The submitted planning proposal has potential to cause significant structural damage to The Priory as the proposal includes excavating a depth of soil of 4.9m below the foundation level of the north-west corner of the property.

Effect of proposed construction of new level of basement at 7 Branch Hill

PLANNING PROPOSAL FOR 7 BRANCH HILL

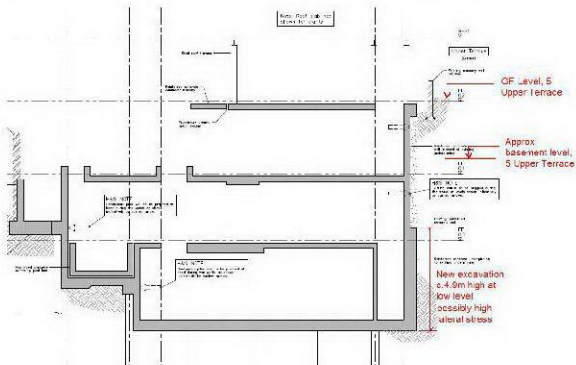
- The excavation for the new basement will be at a level significantly below the basement of 5UT (see fig below). The stress levels will be relatively high and the deposit is essentially a sand, though groundwater is probably below excavation depth. For underpinning, it will be essential to support the underpins as stiffly as possible throughout construction.

Figure 2.18 Relationship between damage category, deflection ratio and horizontal tensile strain (after Burland, 2001)

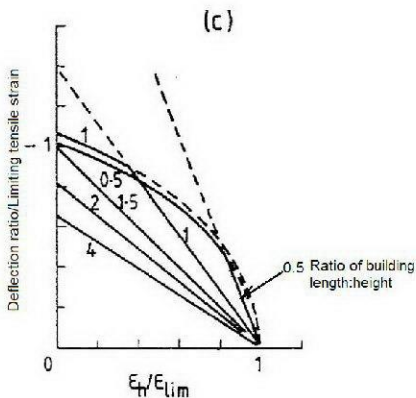
These are solely based on CIRIA C580. A more rigorous analysis should be carried out to determine the ground response. The heave resulting from unloading of vertical stress needs to be estimated. Damage criteria should be based on the attached table and graph and must take into account the distortion of the building as well as the strain. The figures given on Drg P008 suggest a horizontal strain of about 0.15% in the walls close to the corner of 5UT. This is high and should be considered in more detail.
